## **ADDENDUM NO. 05**

PROJECT: South Orangetown Central School District  
PHASE 1: 2022 BOND

CPL PROJECT NO. 14457.20

DATE: November 20, 2023

Drawing Number  
**WOS A110**

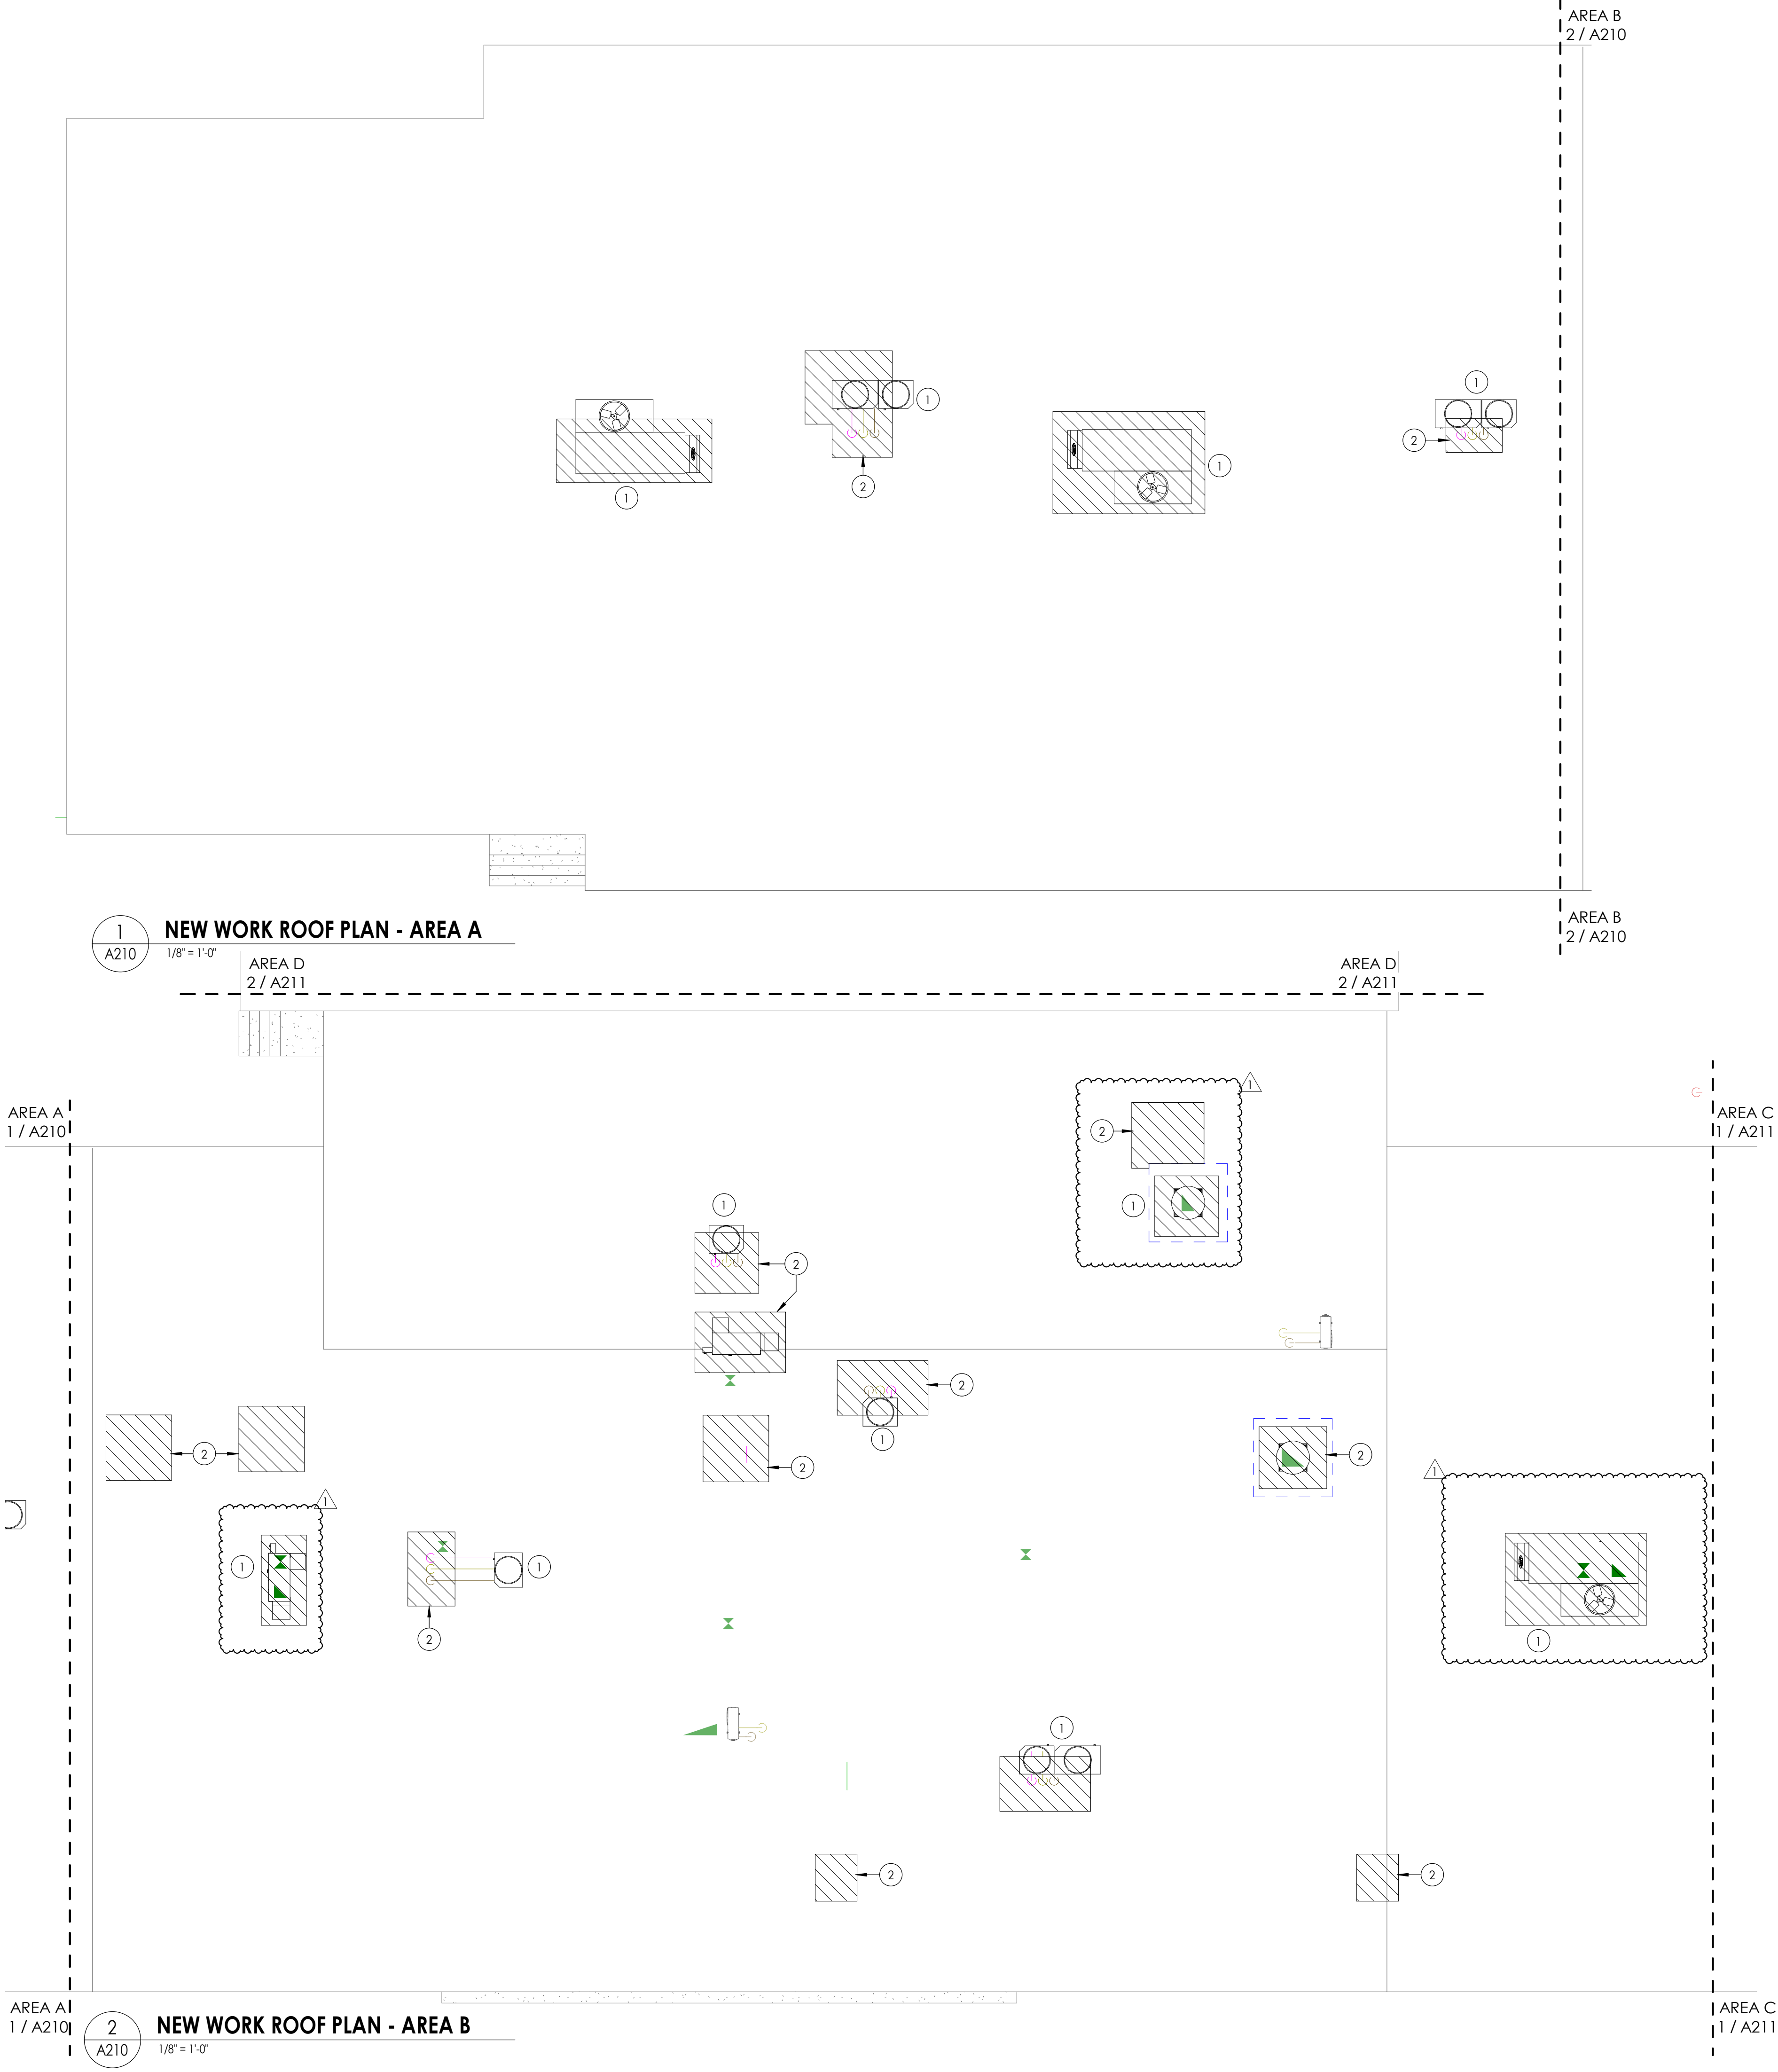
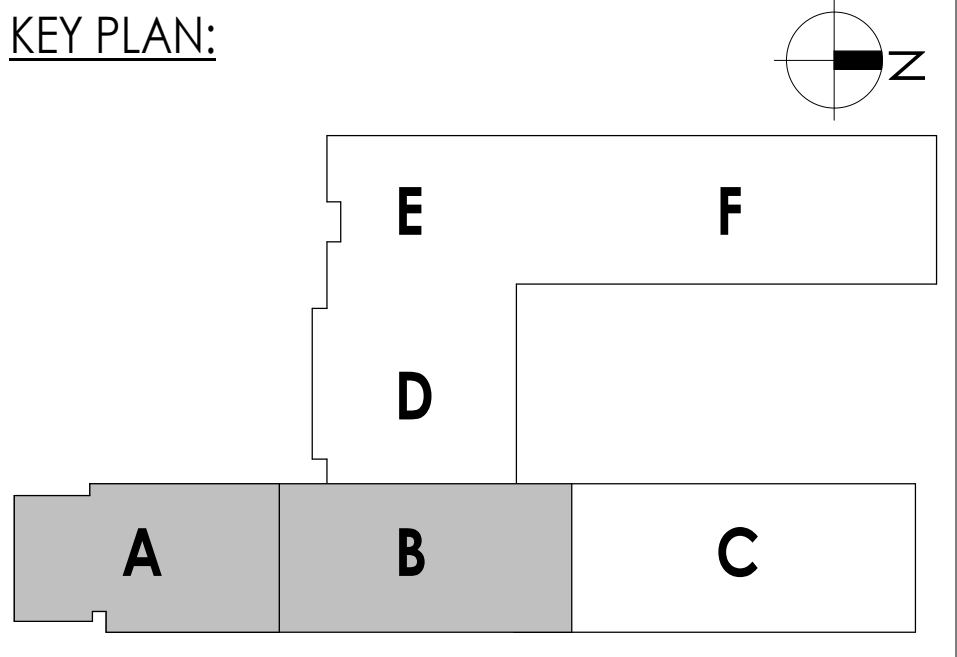
- 3.1 Drawing WOS A110: Replace with attached revised WOS A110
- 3.2 Drawing WOS A210: Replace with attached revised WOS A210.
- 3.3 Drawing CLE A501: Add the following General Note:  
**NOTE:** ALL EXPOSED STEEL COMPONENTS AT NEW ENTRY CANOPY TO BE PAINTED TO MATCH SPECIFIED ALUMINUM SHEET METAL FINISH.
- 3.4 Drawing CLE A900: Replace with attached revised CLE A900
- 3.5 Drawing CLE I200; Elevation 2; Replace Vinyl Signage note to read as follows:  
TAKEFORM – ETHOS PAINTED APPLIQUE LETTERING, OR APPROVED EQUAL. REFER TO SPEC SECTION 101419. ADHESIVE MOUNT BACKING; TEXT HEIGHT: 10".
